**WORCESTER TOWNSHIP PLANNING COMMISSION MEETING
WORCESTER TOWNSHIP COMMUNITY HALL
1031 VALLEY FORGE ROAD, WORCESTER, PA 19490
THURSDAY, FEBRUARY 27, 7:30 PM**

3. Meadowood Senior Living – 3205 Skippack Pike – (LD 2020-01) – Tim Woodrow, Engineer for the Applicant, provided an overview of the proposed lot consolidation.

I am in receipt of the Township's memorandum dated July 27, 2020 requesting my review of the preliminary land development plans for the new memory care facility at the Meadowood Senior Living facility. The plans consists of 27 sheets, are dated July 13, 2020 and have been prepared by Woodrow & Associates, Inc., for Meadowood. The plans propose the construction of a memory care building which will consist of 20 units, and additional areas for support staff. The plans also show the construction of a new parking lot adjacent to the Victory Garden area. A trail and new pedestrian bridge is also part of the land development plan. Also included with the submission is a post construction Stormwater Management Report dated July 2020, also prepared by Woodrow & Associates and an Erosion and Sediment Control Report, dated July 2020, prepared by Woodrow & Associates.

RE: **

Attachment 1: Reduced Copy of Plan

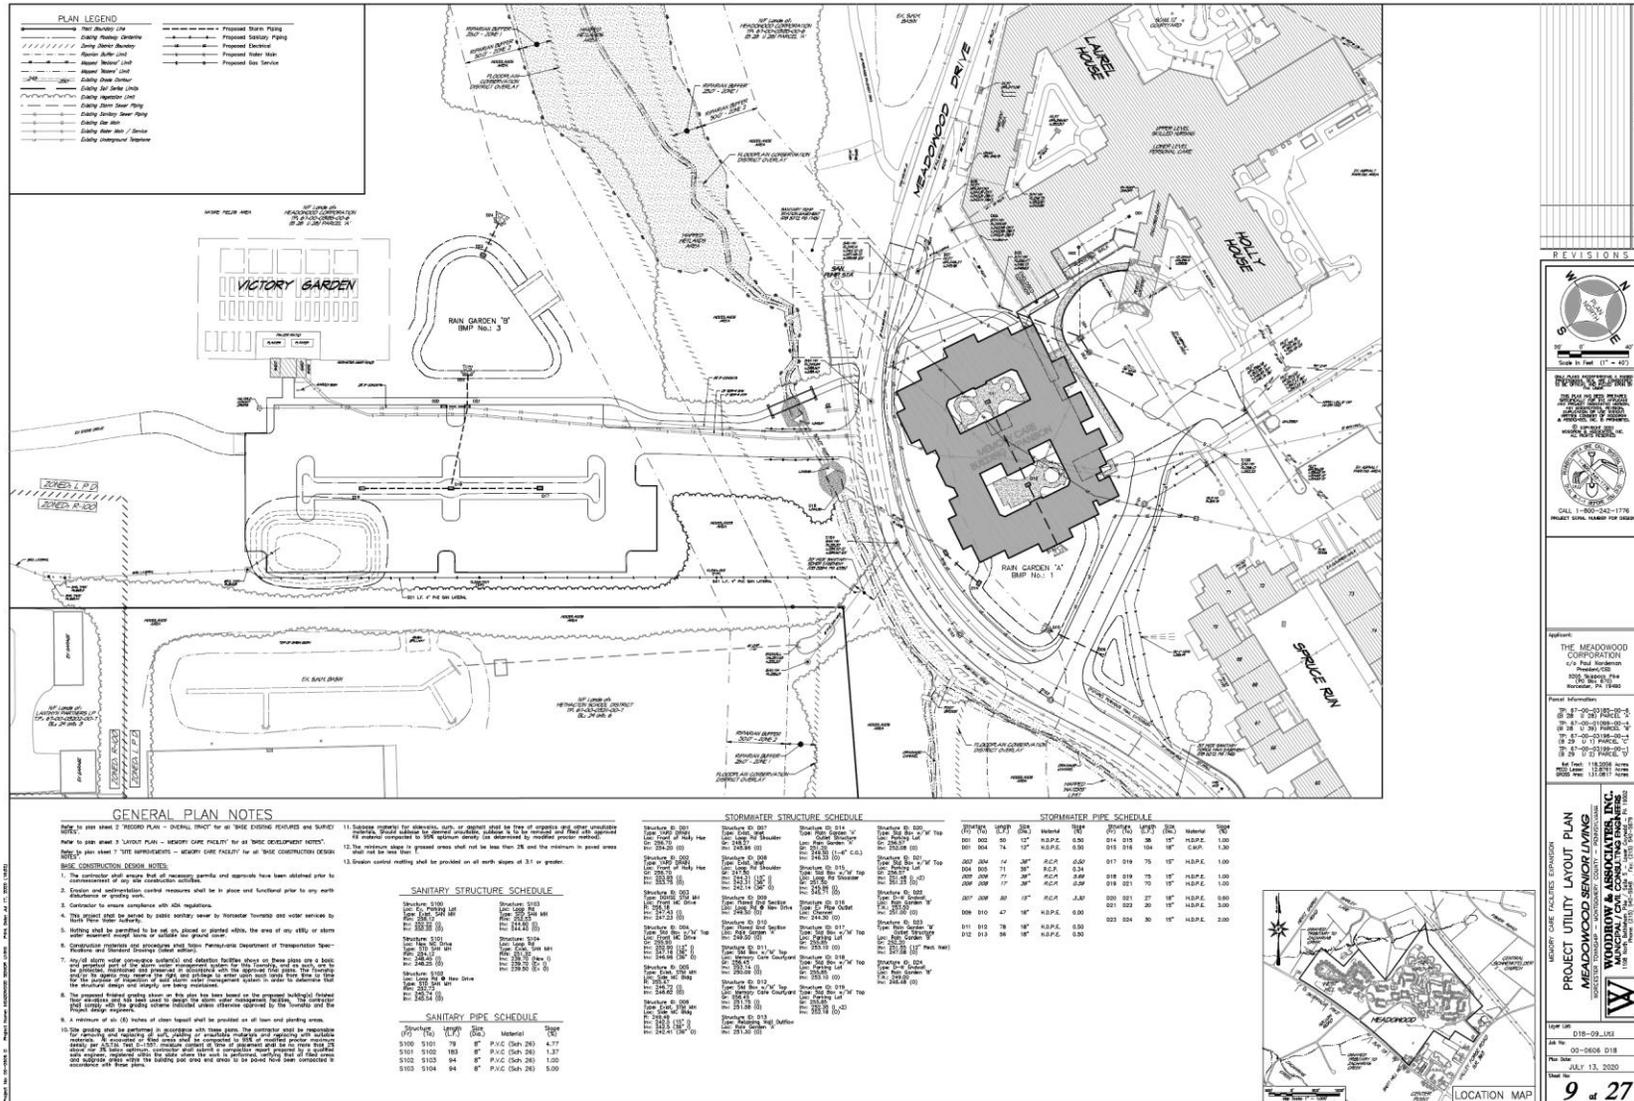
1. Sidewalk Lighting. There will be additional sidewalk/asphalt trail installed along the whole frontage of the new building along Meadowbrook Drive, which we endorse. However, a similar lighting treatment to new loop trail to the north has not been added along this frontage. The township should discuss with the Applicant whether additional lighting in this area is warranted.

2. Light Standards. It is not clear from the site lighting cut sheet what the proposed standard height is for the proposed site lighting. The Applicant should clarify this and ensure that the height is according to township standards.

3. Pervious Trail. The asphalt trail looping the new Memory Care building, as well as that trail leading to the new parking lot, is identified as "pervious." However, the cross-section specification for the "loop trail" in the construction details does not appear to be of a pervious design. This should be revised by the Applicant to a pervious specification to the satisfaction of the township.
